ACCESS PERMIT APPLICATION

Permit # AC 2024-03
Parcel ID: _____

Application Date: 6/7/23 Physical Address of Property: 700 Stage Rd / 123 Brooks Rd.
 Applicant Name: Ken Paquette Property Owner Name: Jared Paquette
 Applicant Mailing Address: _____ Owner Mailing Address: _____
10256 Williston Rd 10256 Williston Rd
Williston VT Williston VT 05495
 Phone: 802 363 7697 Phone: 802 324 9595
 Email: Ken@vermontnursery.com Email: _____
 Description of Project: Agricultural Access + Driveway Is property in floodplain? No

Sketch Plan:

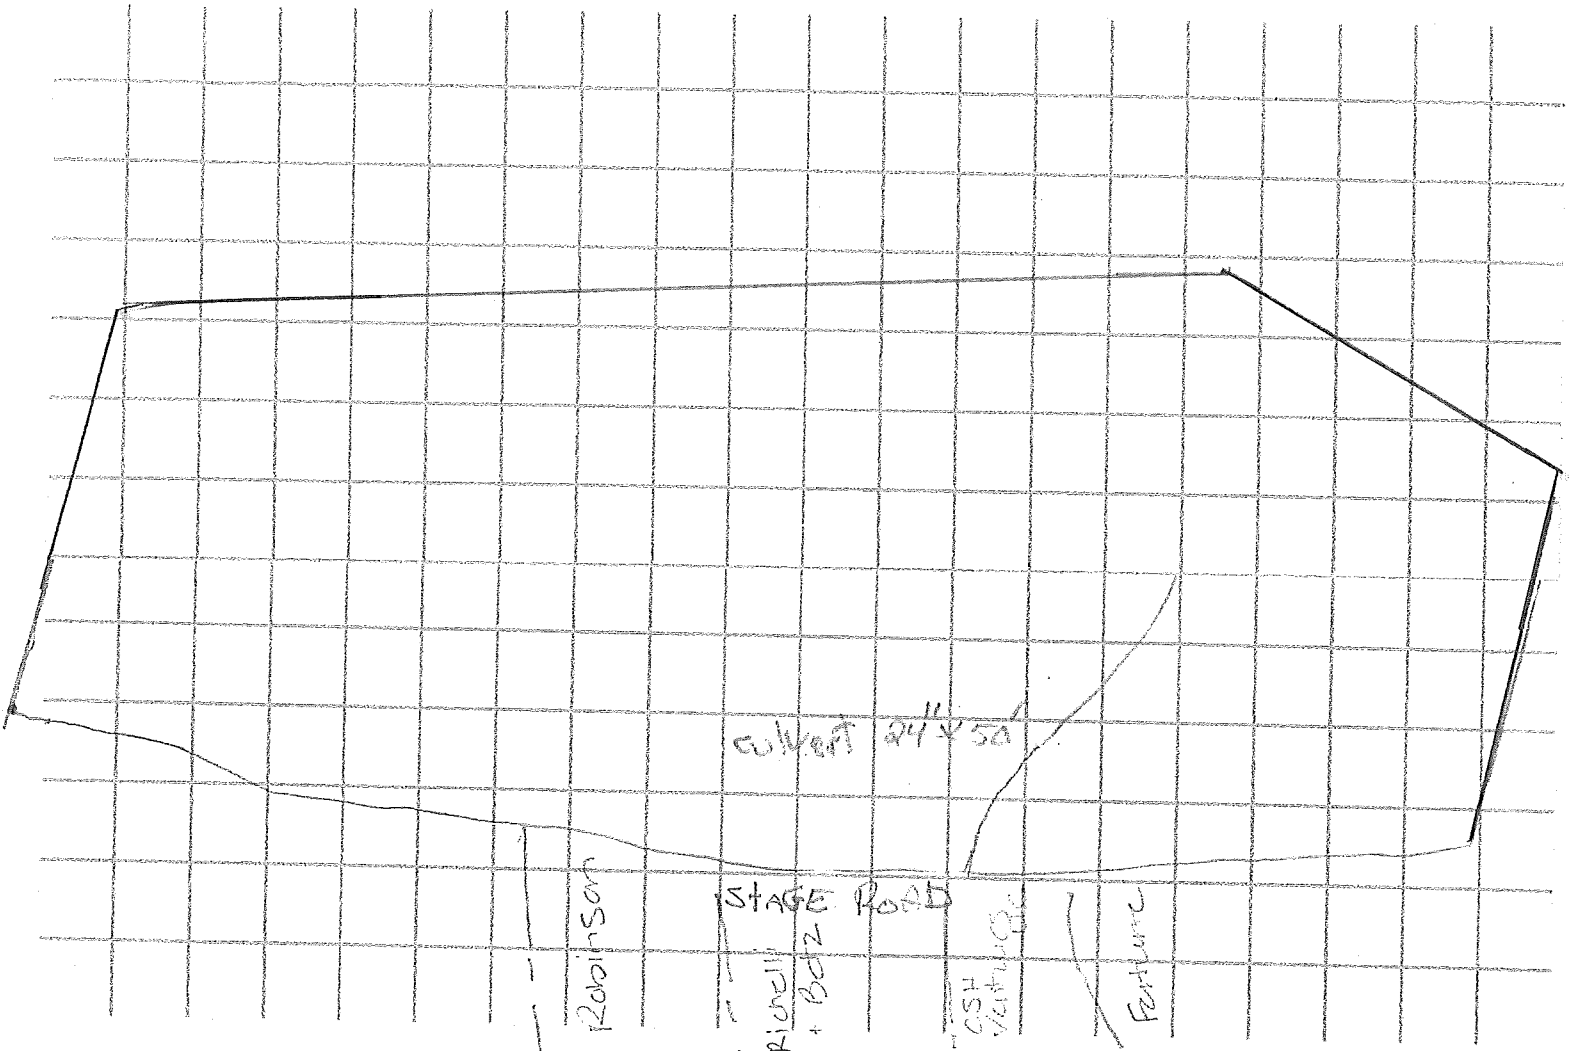
Application received by ZAO & forwarded to Highway Department (date & initial): JM/6/12/23 Fee: US
 Application received & reviewed by Highway Department (date): 6-27-23 Decision: APPROVED / DENIED / WITHDRAWN
 Comments: 18" x 40' HOPE CULVERT IN PLACE. Additional comments on reverse _____
 Highway Foreman Signature: [Signature] Date: 6-27-23
 Application received by Town Manager and scheduled for Selectboard approval (date of SB meeting): 7/5/23
 Selectboard Decision: APPROVED / DENIED / WITHDRAWN Comments: _____
 Selectboard Chair Signature: _____ Date: _____
 Return approved application to Planning & Zoning Office for applicant notification and filing (ZAO date & initial): _____

Highway Department Comments: CULVERT IS NEWLY INSTALLED. SIGHTLINE FROM ACCESS LOOKING NORTH IS 480'. SIGHTLINE FROM ACCESS LOOKING SOUTH IS 500'. SIGHT DISTANCE EXCEEDS B-71 MINIMUM OF 250'.
